Rolls-Royce

TV No.	289517	Issue:	1	Date of Application:	06 February 2025
Application Type	One-off <input checked="" type="checkbox"/> Repeater <input type="checkbox"/>			Expiry date (If Repeater)	N/A
Operator/Applicant	EXECUTIVE JET MANAGEMENT INC / ROLLS-ROYCE CANADA LIMITED			Original Request No.	BR25-057
Engine Type	BR700-710			Engine Mark/Model (s)	A1-10
Part Description	ENGINE			Eng/Mod Serial No.	11498 / N/A
Part No.	REFER TO TABLE 1			Part Serial No.	N/A
Manual Title	ENGINE MANUAL	Ref.	E-710-1BR	ATA/DMC Ref.	72-00-51
TV Title	ACCEPT OVERSIZED GAP BETWEEN 3-OFF DIAPHRAGM ASSEMBLIES				
Hours	HSN: 10585.1 (MODULE)	Cycles	CSN: 4340 (MODULE)

Technical Variance Approval Sheet

TV No. 289517
Issue 1
Version 1

Figure 1: Inspection Locations on the Diaphragm Assemblies

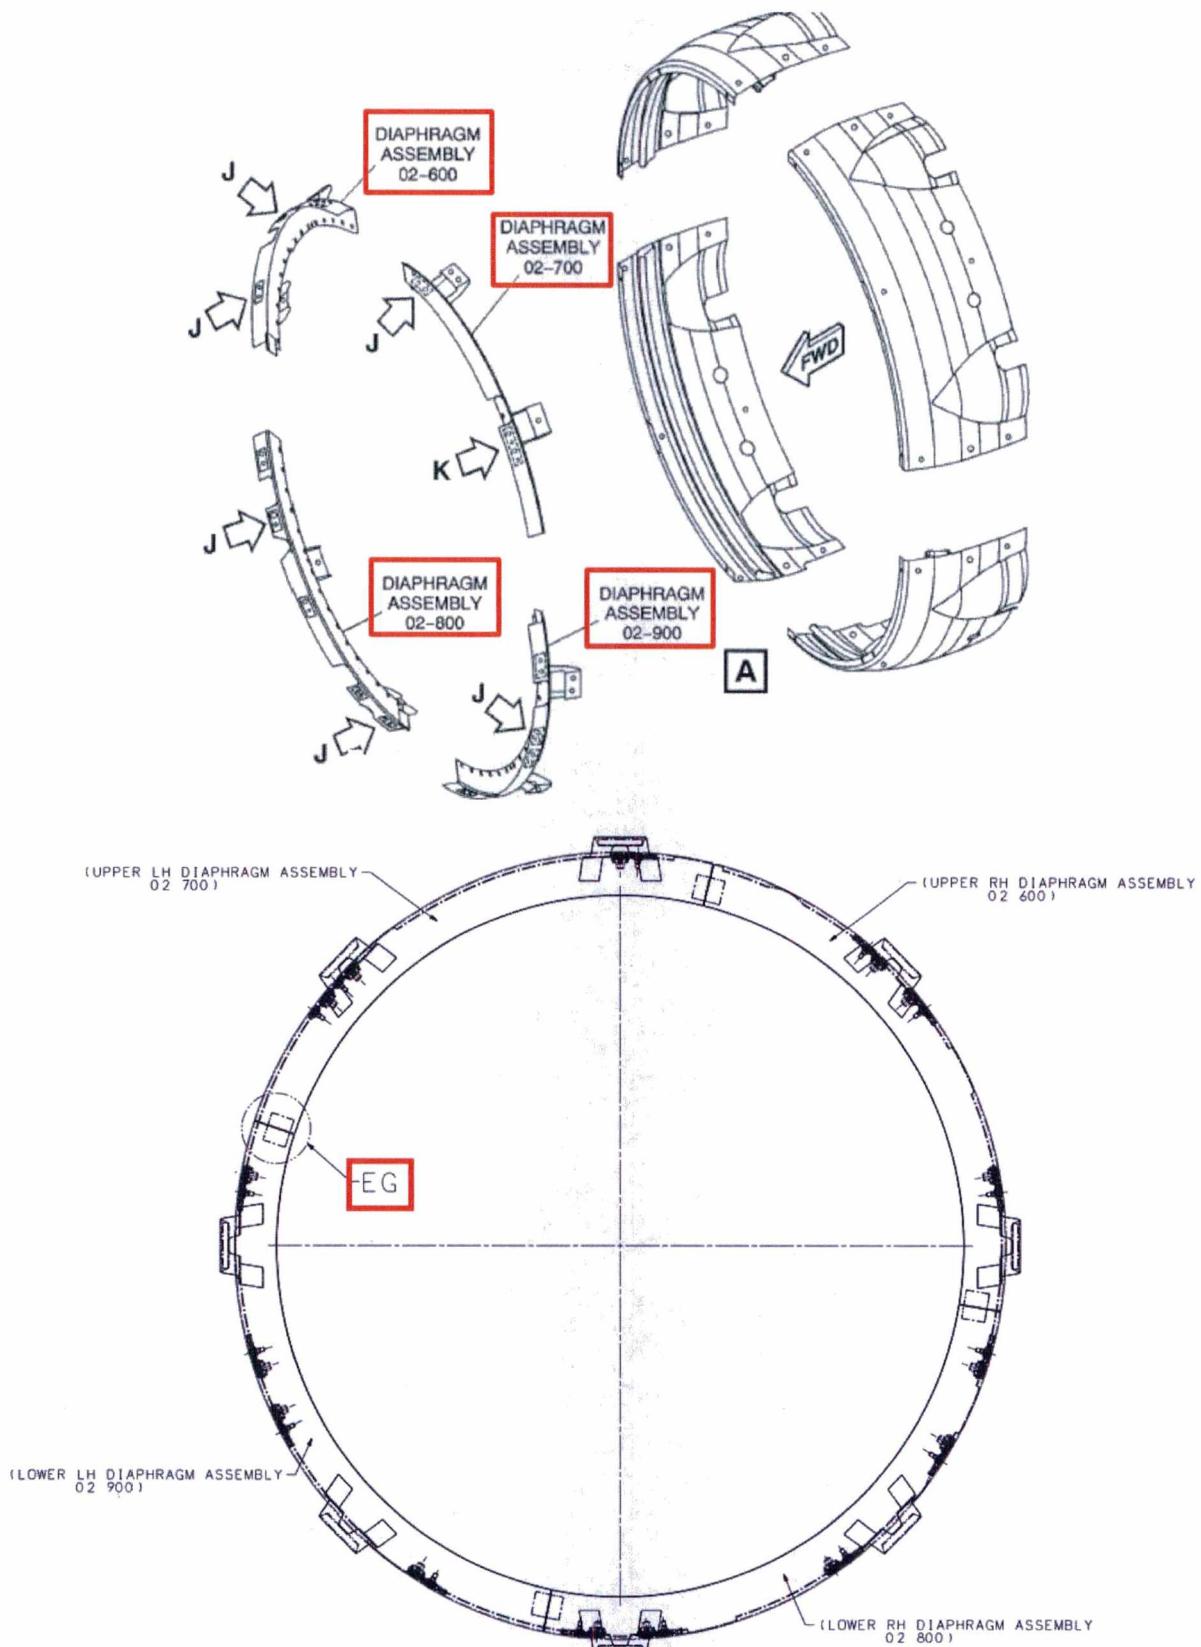
The requested Technical Variance (TV) is raised to accept the subject engine exhibiting gap between 3-off Diaphragm Assemblies as detailed in Table 2 on page 2 of this TV.

Refer to figures on pages 3 to 5 for inspection locations and photo of damage.

Deviation details	Measured Gap between Diaphragm	Deviation from EM
Measured over gap between 3-off Diaphragm Assemblies	3,4 mm (0.13 in)	1,4 mm (0.05 in) more than EM limit

- Accept the deviation in gap between 3-off Diaphragm Assemblies in as-is condition.
- Make a record of this TV289517 in the applicable records.

Figure 2: Gap between Diaphragm Assemblies (Referred from Fitting Instruction Drawing: KH12724)

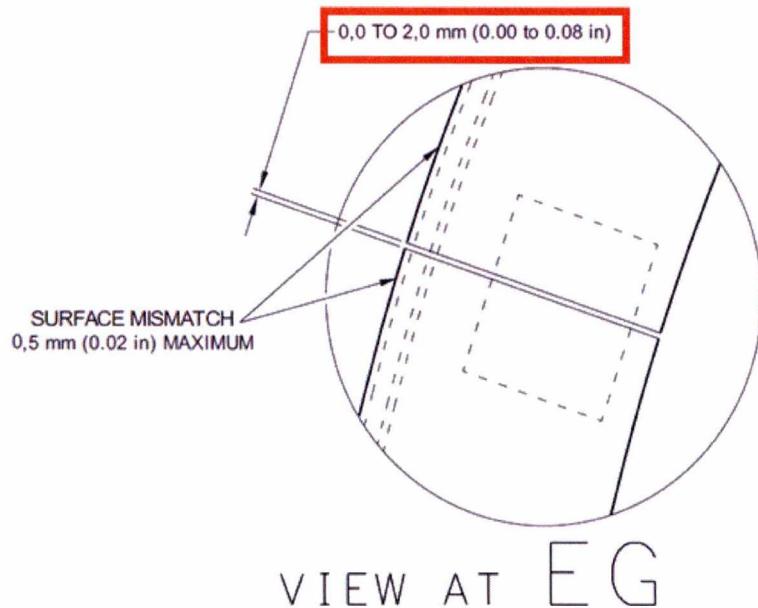
Engine Manual (EM) TASK 72-00-51-400-001 'Install the LP Turbine Module' SUBTASK 72-00-51-420-006, 22. Install the LP Turbine Module instructs to install the diaphragm assembly on the flange maintaining a gap between each diaphragm assembly between 0,0 mm to 2,0 mm (0.0 in to 0.08 in) with the surface mismatch not greater than 0,5 mm (0.02 in). Refer to figure 2 on page 4 of this TV.

Figure 3: General view to show affected engine with deviated LPT Module Diaphragm Assemblies

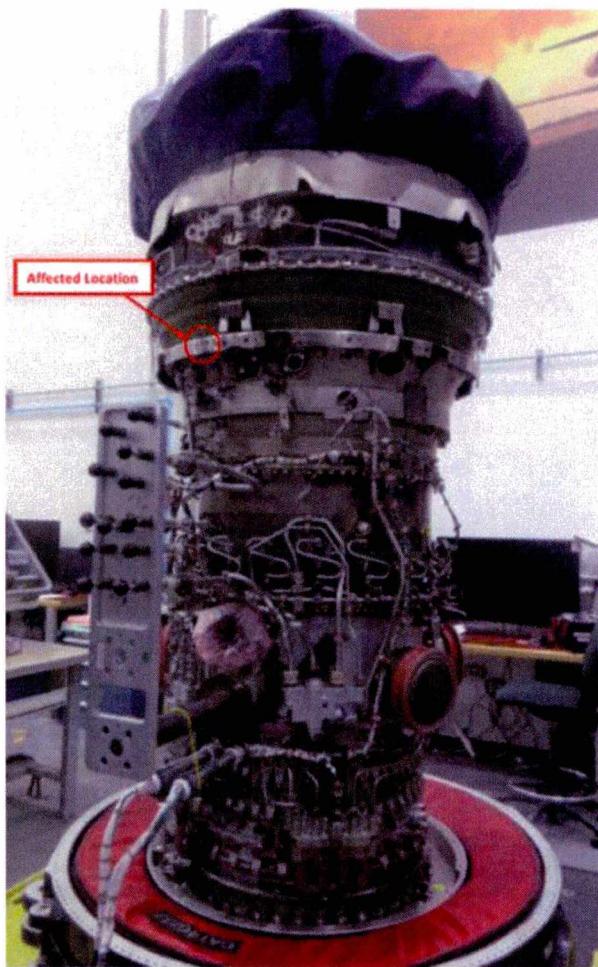
ESN 11498 was removed due to fuel nozzle cracked burner sleeve.

Figure 4: Typical view to show gap between Diaphragm Assemblies

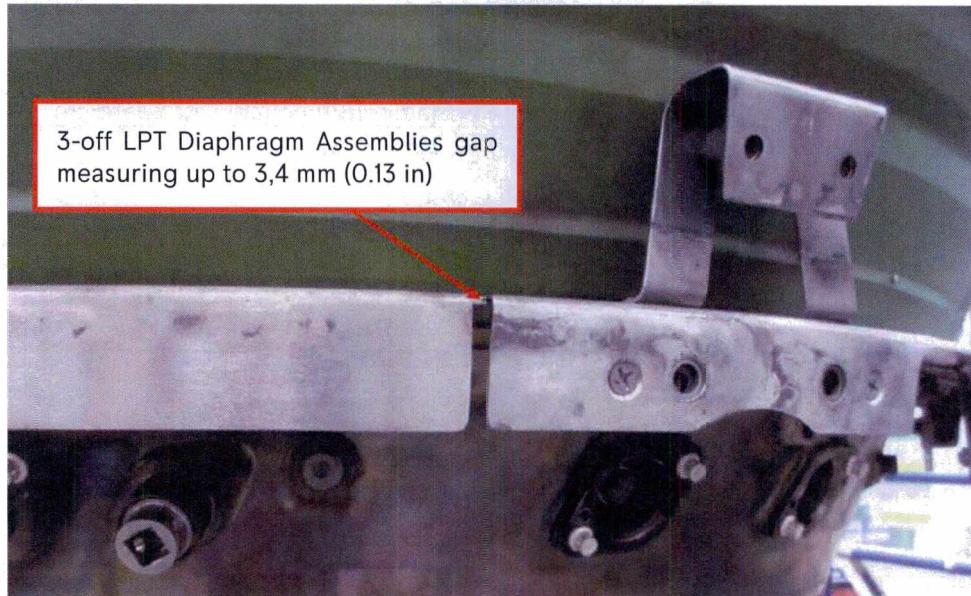
The subject ESN 11498 exhibits deviation in gap between 3-off Diaphragm Assemblies. The reported worst gap measures up to 3,4 mm which is 1,4 mm more than EM acceptable limits.

Based on engineering assessment, it is concluded to accept the reported deviation in gap between the Diaphragm Assemblies on LPT Module in 'as-is' condition.

Illustration 1

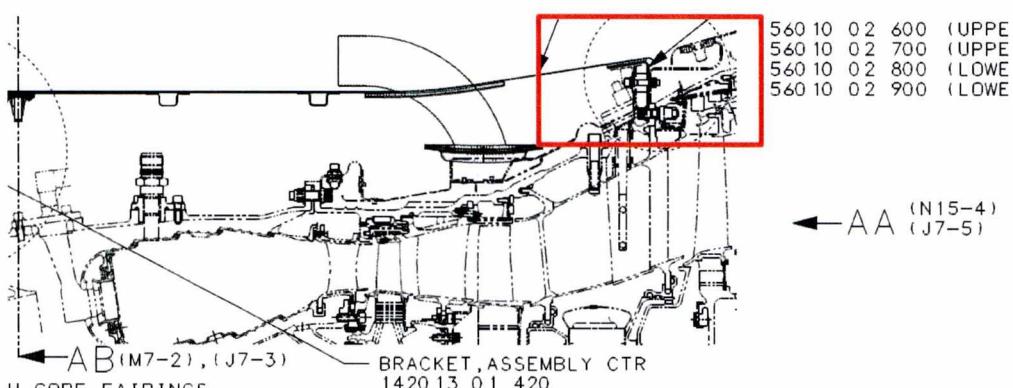
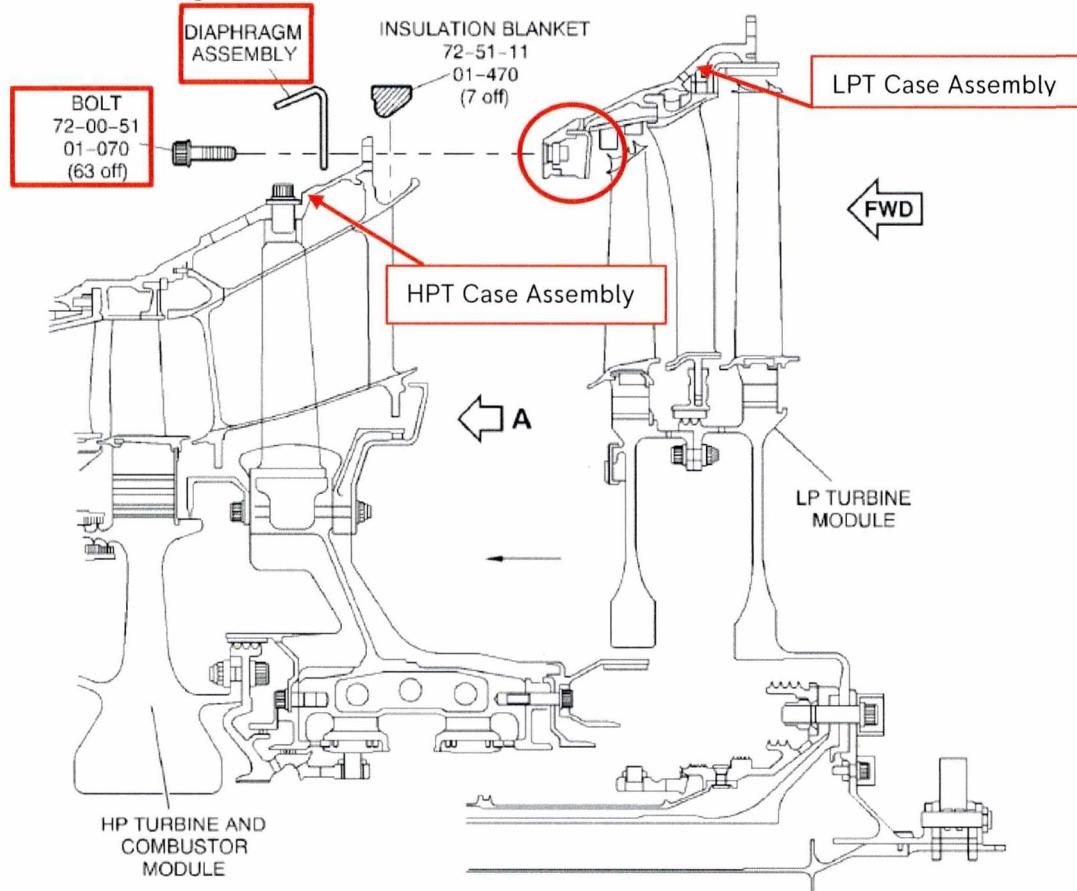
From the general arrangement drawing, it is assessed that the Diaphragm Assemblies (EIPC: 72-00-51, 02-600, 02-700, 02-800 and 02-900) are installed on the front of the HPT/LPT flange using bolts (EIPC 72-00-51, 01-070). Refer to Illustration 1 given below.

PRIOR TO TIGHTENING FASTENERS AT HPT/LPT FLANGE, ENSURE DIAPHRAGMS UINS 1560 10 02 600 TO 1560 10 02 900, ARE FITTED TO GIVE THE BEST ACHIEVABLE COLD BUILD CLEARANCES AS SHOWN (VIEW AT EG K15-5).

It is assessed that the reported Diaphragm Assemblies on the front fixed fairings and forward seal lands with correct position gives the best achievable cold build clearances and will not have any effect on the functionality of the parts.
